EWP M3 External work platform – FAT documentation	25220 Hollandse Kust Zuid
---	---	------------------------------

Mechanical Release Note EWP Rev 2 #15

25220-GEN-RE05-XXX_04 - EWP - Electrical Release Note Rev 4 #9

● **#1231 - Fly rust on the post**

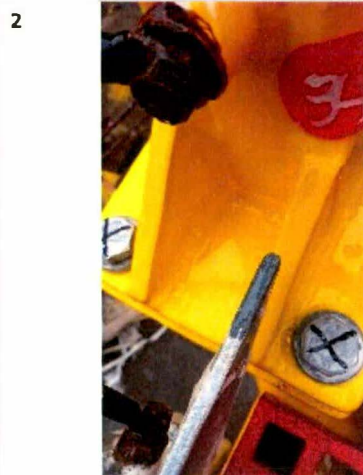
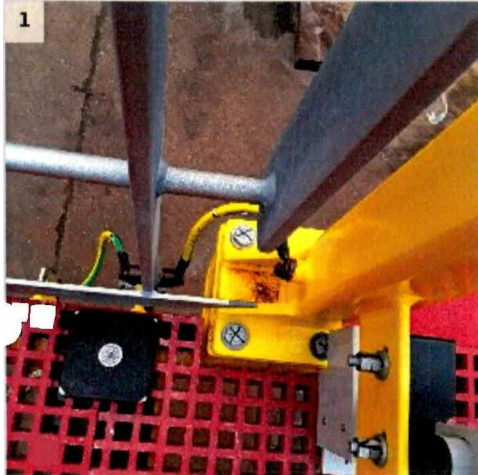
Fly rust on the post @ilchan_chanko #client @TouchUp

● **#1230 - Needs some coating**

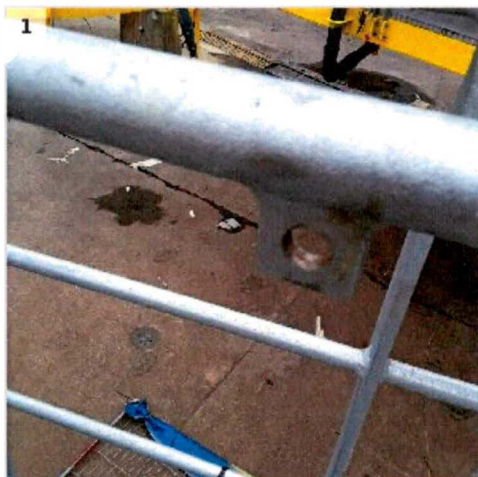
Needs some coating @TouchUp @ilchan_chanko #client

● #1233 - Cut more the plate

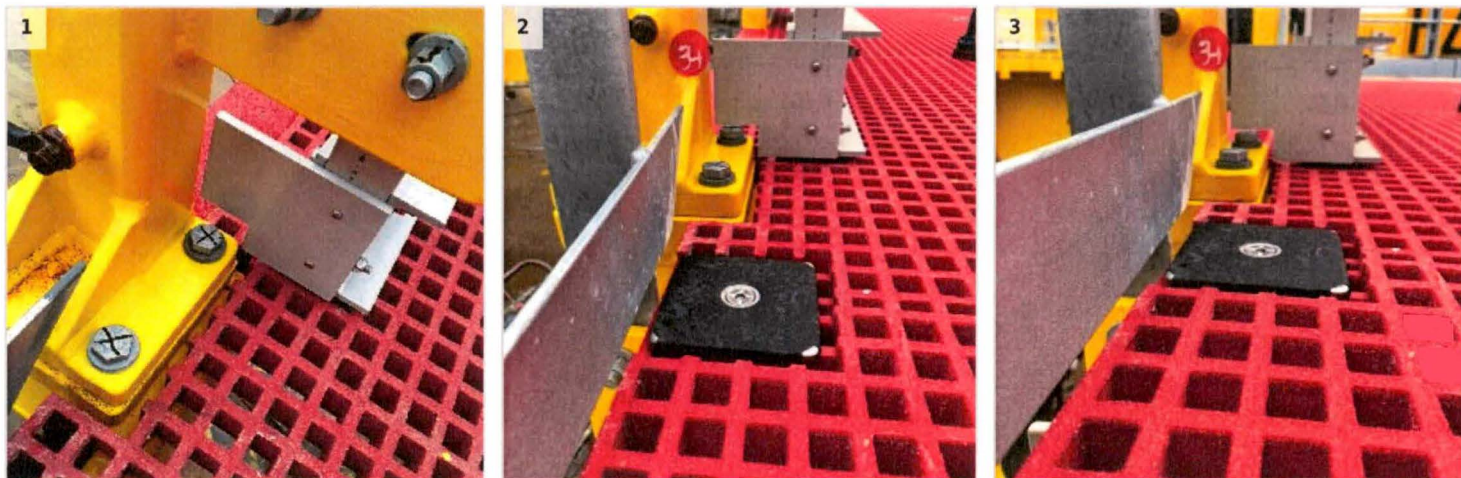
Ben Herygers	Photo 1	19 jun 09:56
Ben Herygers	Cut more the plate @Mechanical @kevin_kemps #client	19 jun 09:56
Marcin Witkowski	Photo 2	22 jun 13:38
Marcin Witkowski	Photo 3	22 jun 13:38

● #1370 - Paint missing and put some glue on the rubber

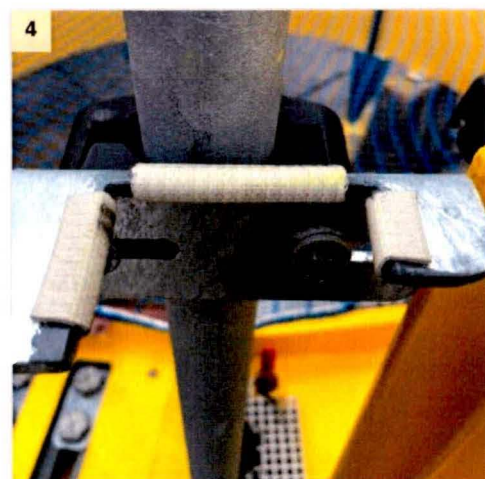
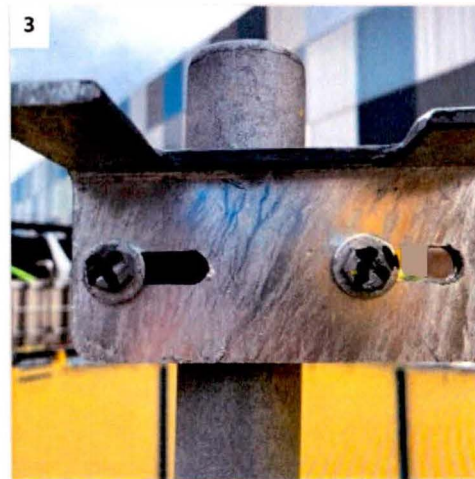
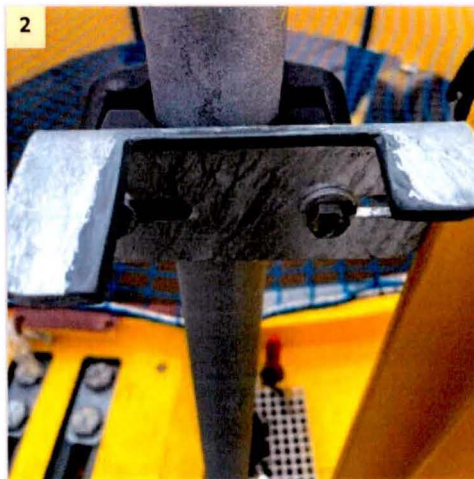
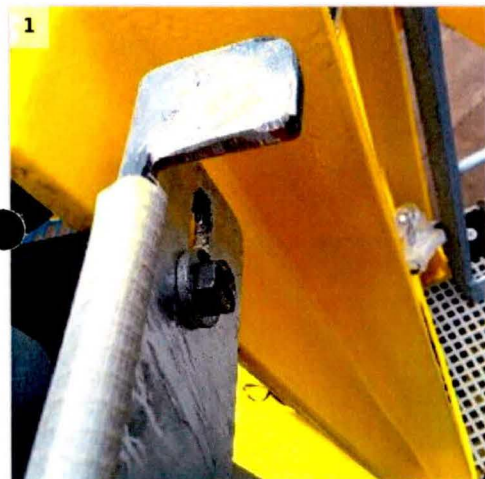
Ben Herygers	Photo 1	24 jun 13:31
Ben Herygers	Paint missing and put some glue on the rubber @Mechanical @kevin_kemps @ilchan_chanko #client	24 jun 13:32
Marcin Witkowski	Photo 2	24 jun 16:01
Marcin Witkowski	Photo 3	24 jun 16:01
Marcin Witkowski	Photo 4	24 jun 16:03

#1221 - Bracket touches the plate

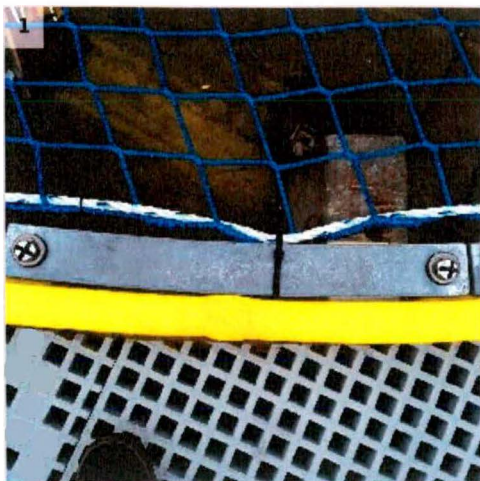
Ben Herygers	Photo 1	19 jun 09:37
Ben Herygers	Bracket touches the plate @Mechanical @kevin_kemps #client	19 jun 09:37
Marcin Witkowski	Photo 2	23 jun 14:00

#1226 - Wrong weld used. Stainless steel??

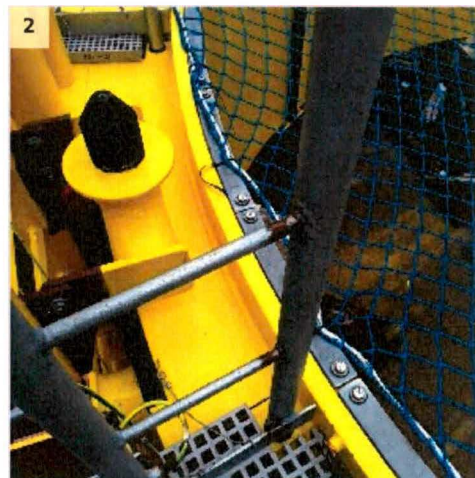
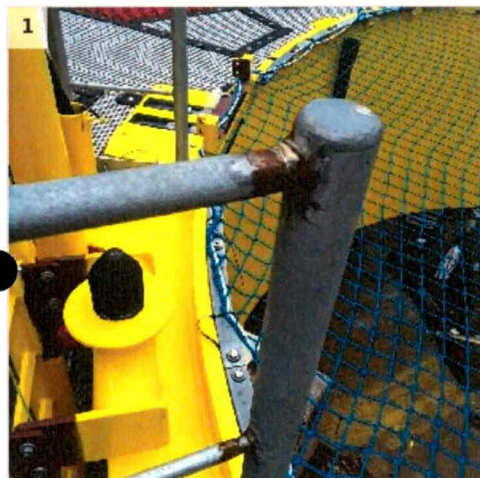
Ben Herygers	Photo 1	19 jun 09:45
Ben Herygers	Photo 2	19 jun 09:45
Ben Herygers	Wrong weld used. Stainless steel?? @Mechanical @kevin_kems #client	19 jun 09:46
Kevin Kems	weld white kryo 1 according WPS (welder Pedro)	21 jun 13:50
Marcin Witkowski	Info Kevin NCR while being made	23 jun 09:55

#1229 - Needs to be adjusted

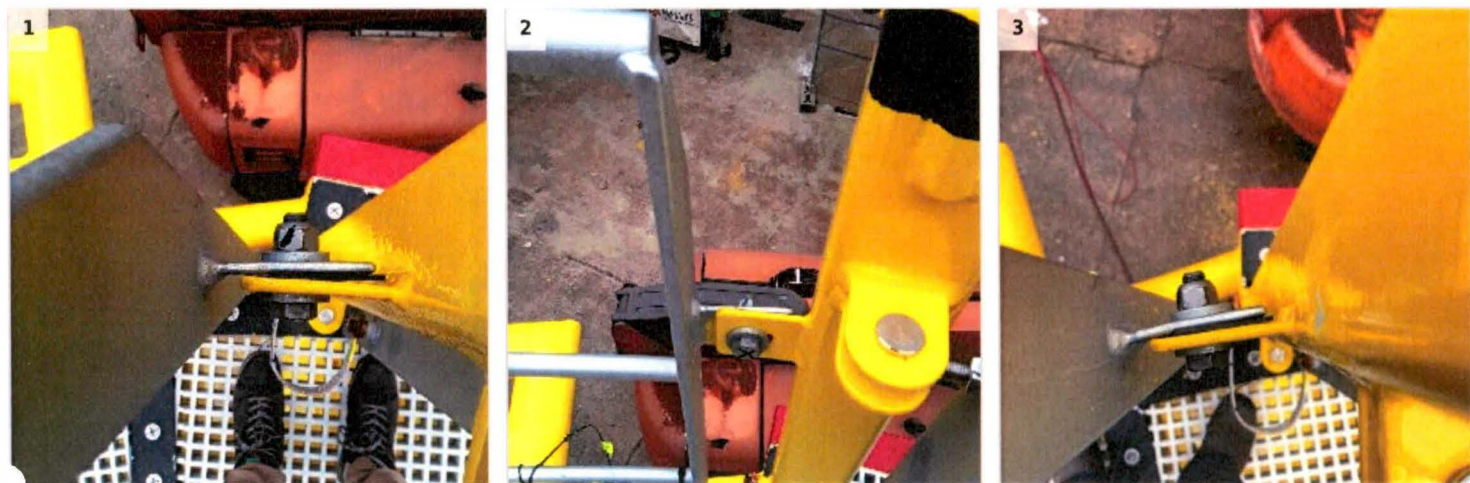
Ben Herygers	Photo 1	19 jun 09:52
Ben Herygers	Photo 2	19 jun 09:52
Ben Herygers	Needs to be adjusted @Mechanical @kevin_kemps #client	19 jun 09:52
Marcin Witkowski	Photo 3	22 jun 13:49

#1228 - Rubber already burst

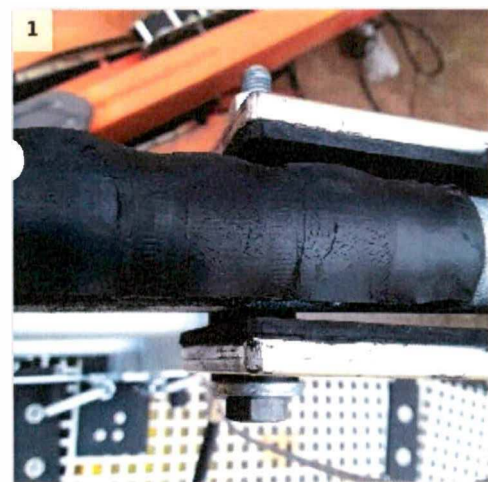
Ben Herygers	Photo 1	19 juni 09:51
Ben Herygers	Rubber already burst @Mechanical @kevin_kemps #client	19 jun 09:51
Kevin Kempes	3 mm installad according drawing	21 jun 13:52

#1218 - To big gap on the finger guide

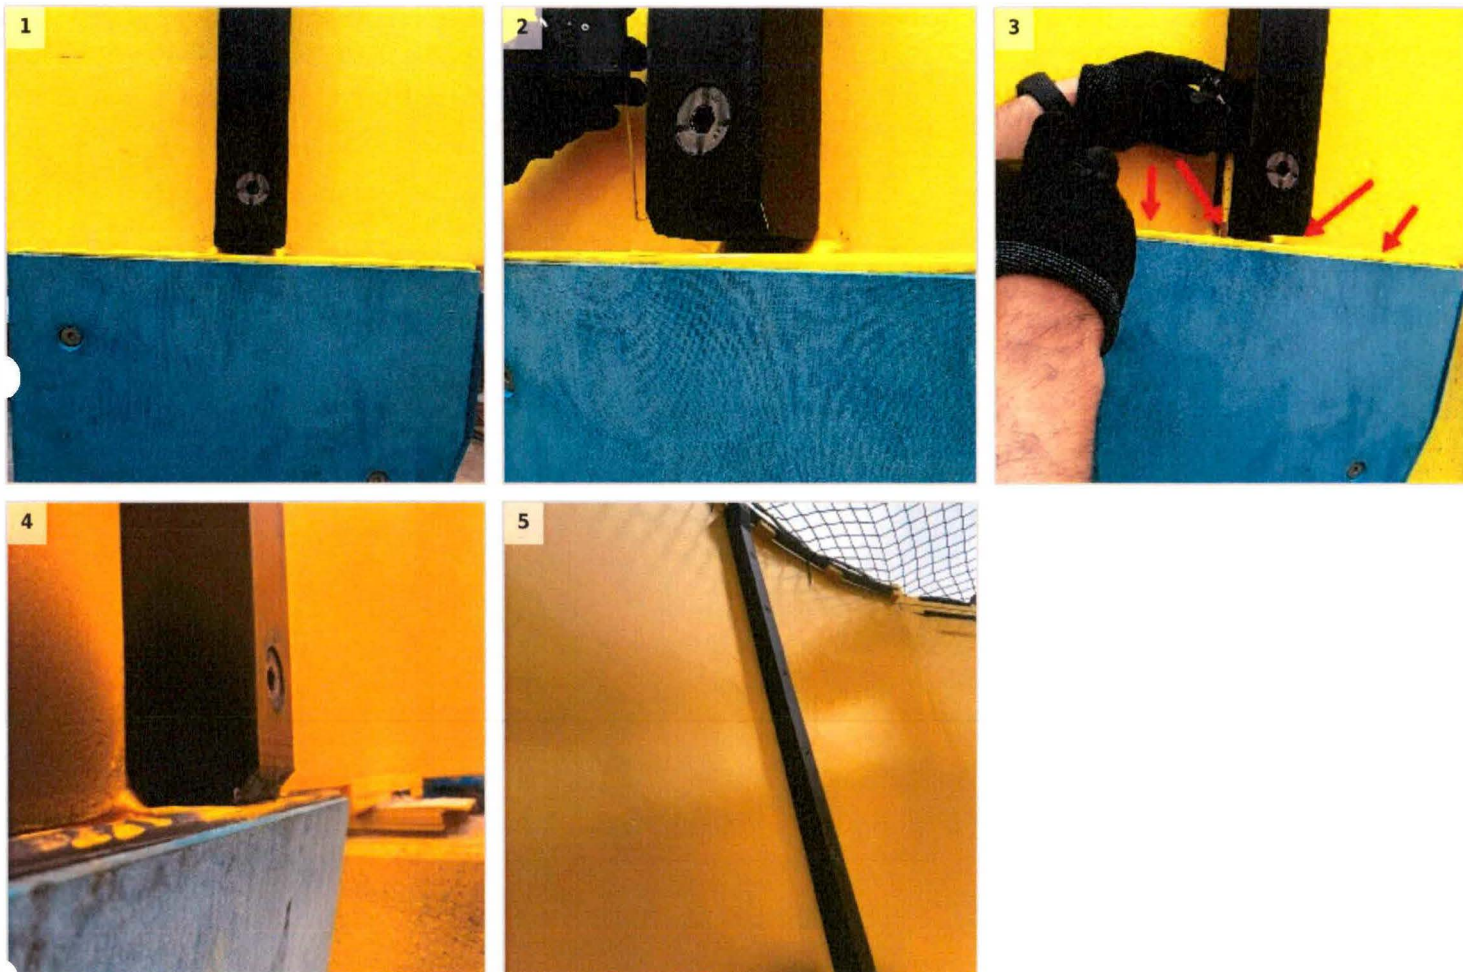
Ben Herygers	Photo 1	19 jun 09:29
Ben Herygers	Photo 2	19 jun 09:29
Ben Herygers	Photo 3	19 jun 09:29
Ben Herygers	To big gap on the finger guide @Mechanical @kevin_kemps #client	19 jun 09:30
Marcin Witkowski	Photo 4	24 jun 07:55
Marcin Witkowski	Photo 5	24 jun 07:55

● #1225 - Lockpins don't fit well

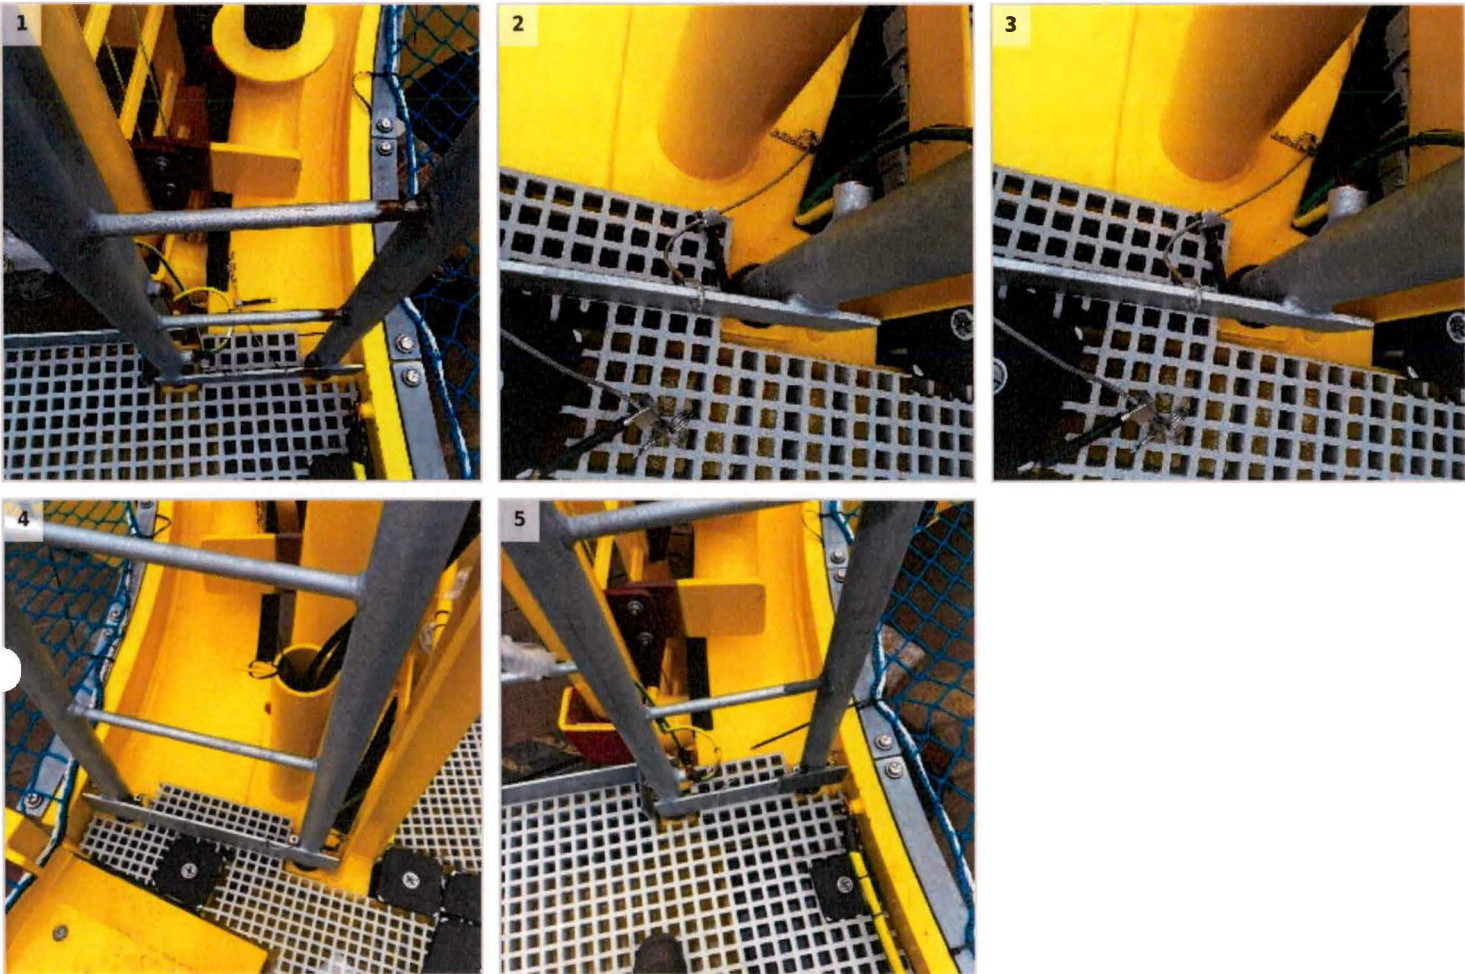
Ben Herygers	Photo 1	19 jun 09:44
Ben Herygers	Photo 2	19 jun 09:44
Ben Herygers	Photo 3	19 jun 09:44
Ben Herygers	Lockpins don't fit well @Mechanical @kevin_kemps #client	19 jun 09:45
Marcin Witkowski	Photo 4	23 jun 15:58
Marcin Witkowski	Photo 5	23 jun 15:58

#1220 - Put new bolt. Start already rusty

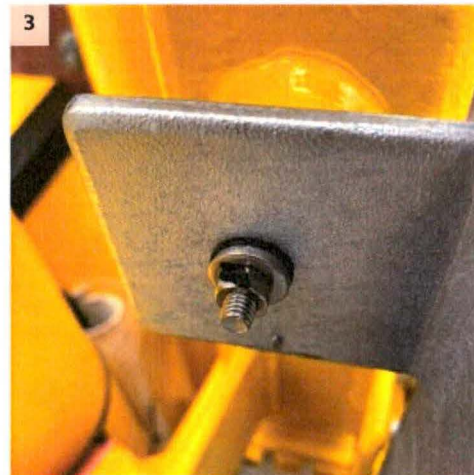
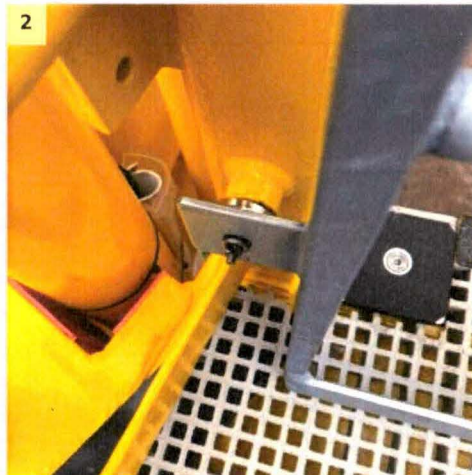
Ben Herygers	Photo 1	19 jun 09:36
Ben Herygers	Put new bolt. Start already rusty @Mechanical @kevin_kemps #client	19 jun 09:37
Marcin Witkowski	Photo 2	23 jun 14:00
Marcin Witkowski	Photo 3	23 jun 14:01

● #1223 - Needs black ones for UV protection

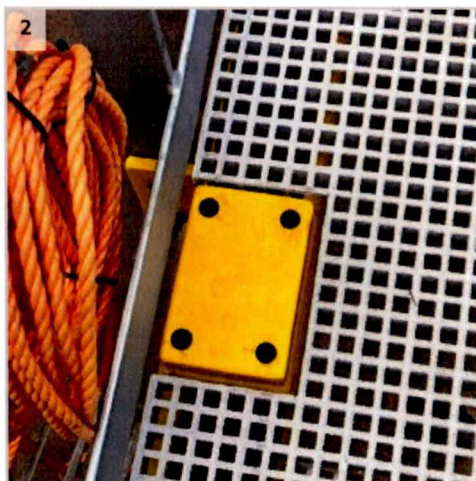
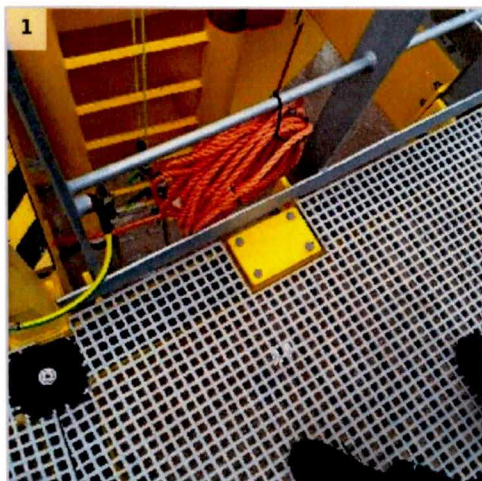
Photo 1
Needs black ones for UV protection @Mechanical @kevin_kemps #client
Photo 2

H3M3	Rev. 2	Date: 24.06.2021

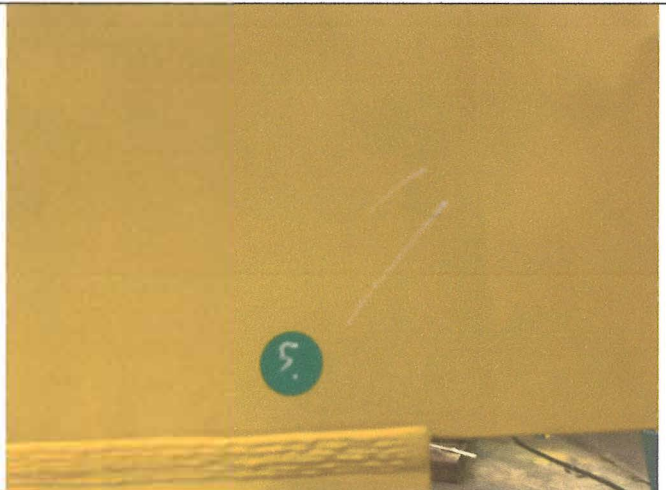
No. 1 – Top coat repair, smoothing of the edge required.	No. 2 – Burn marks, fly rust, cleaning and topcoat repair required.

No. 3 – Pour touch up, inclusions, topcoat repair required.	No. 4 – General comment, cleaning required.

No. 5 – Fly rust and burn marks, cleaning and topcoat repair required.	No. 6 – Another layer of topcoat required.

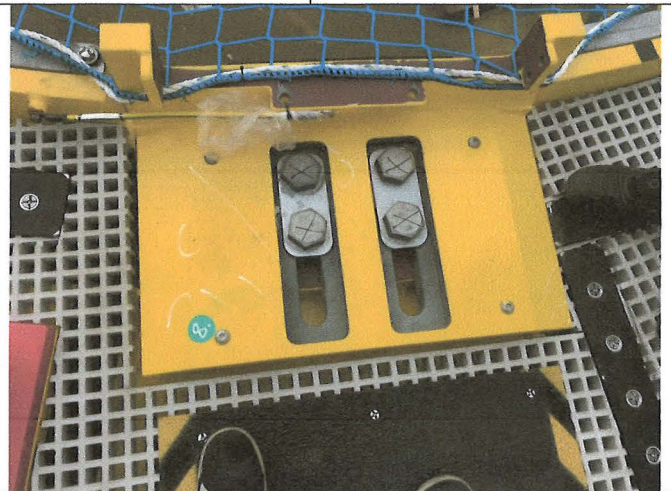
No. 7 – B. L. upper ladder, bolt holes must be sealed and top coated.

No. 8 – Mechanical damages, topcoat repair required.

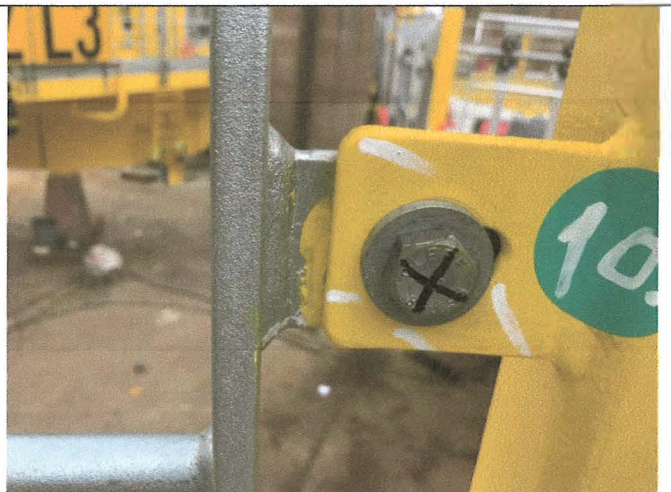
No. 9 – Pour touch up, sanded but not painted.

No. 10 – Pour workmanship, topcoat shall be removed from HDG handrail, additional layer of topcoat required on bracket.

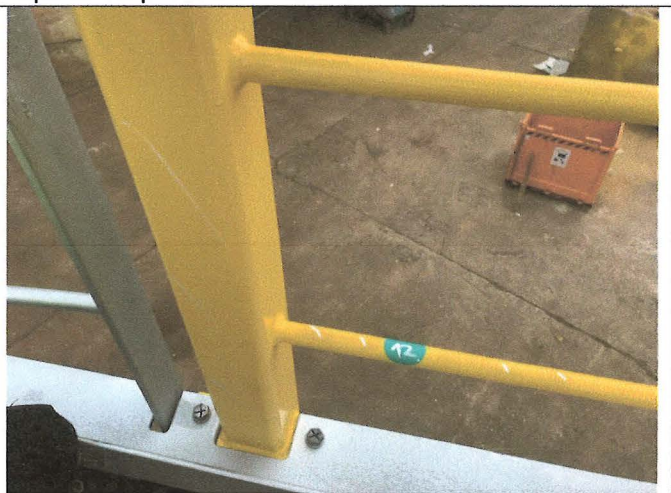
No. 11 – Top coat repair required.

No. 12 – Topcoat repair required.

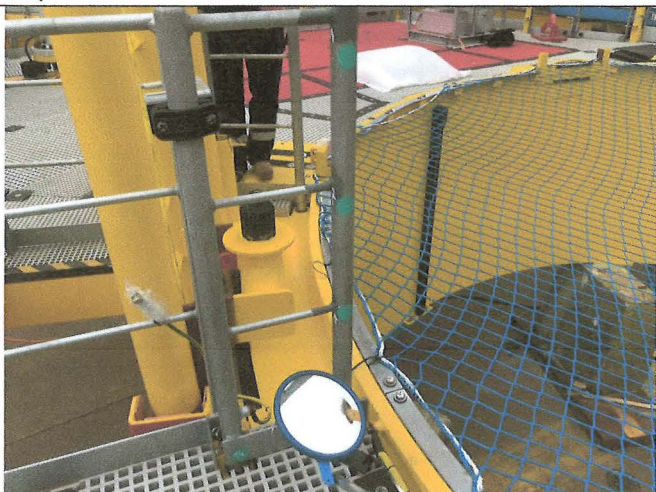
No. 13 - Dirt and fly rust under the gratings. Cleaning required.

No. 14 - Dirt and fly rust under the gratings. Cleaning required.

No. 15 - HDG handrails, not closed film, surface preparation and paint application required.

No. 16 - Dirt and fly rust. Cleaning required.

No. 17 - Kick plate edge, topcoat shall be removed, epoxy repair required.

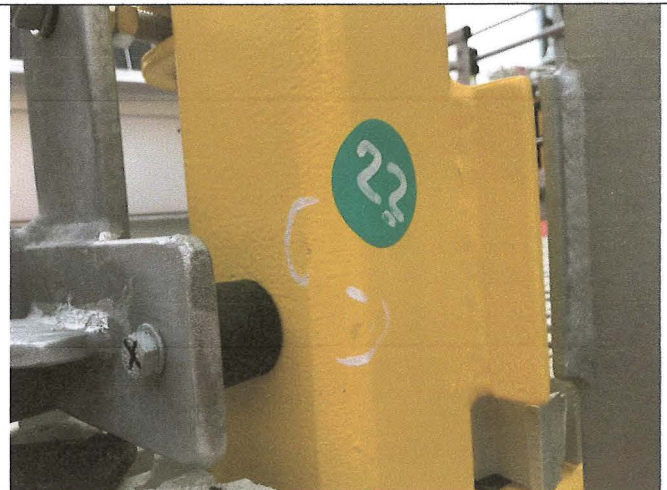
No. 18 - Mechanical damage.

H2M3	Rev. 2	Date: 24.06.2021

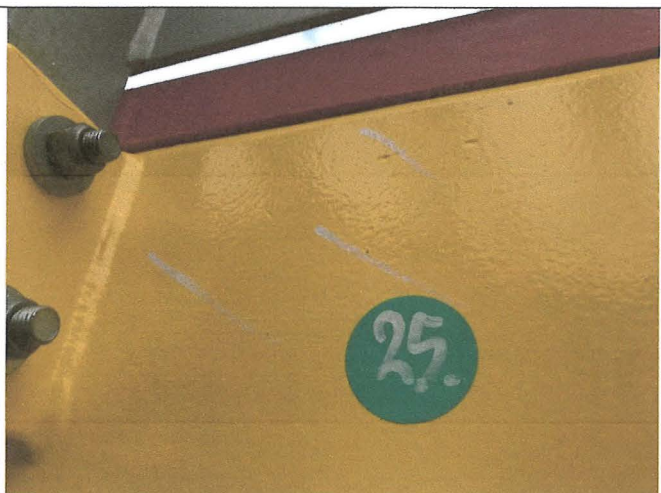
No. 19 – Top coat repair required.	No. 20 – Dirt and fly rust under the gratings. Cleaning required.

No. 21 – Mechanical damage to coating, epoxy repair required.	No. 22 – Mechanical damage. Swing gate, S side.

No. 23 – Mechanical damage. W side UPN.	No. 24 – Topcoat application required. WS side.
